**Indesit** Company

Model type:  
**B34FNFSP**

Commercial code:  
**28909**

## Notices

#### n1030067: Noisy freezer compartment fan in Ariston and Indesit Opera-60 total no-frost fri

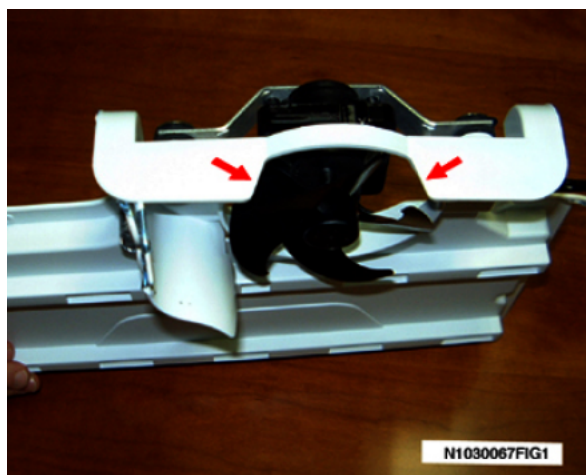
On Ariston and Indesit Opera60 Total No Frost fridge-freezers produced before August 2003, the freezer fan may stop due to ice build-up (stalactites), activating the alarm.

The problem has been solved by emptying the conveyor (chamber separator) in the upper part to give the fan more space (see fig.1).

To solve the problem in products in use, an air conveyor kit (Sat code 094490), which also includes modifications to reduce dispersion air flow, has been introduced since 25/9/2003 (see fig.2) and 06/10/2003 (see fig.3).
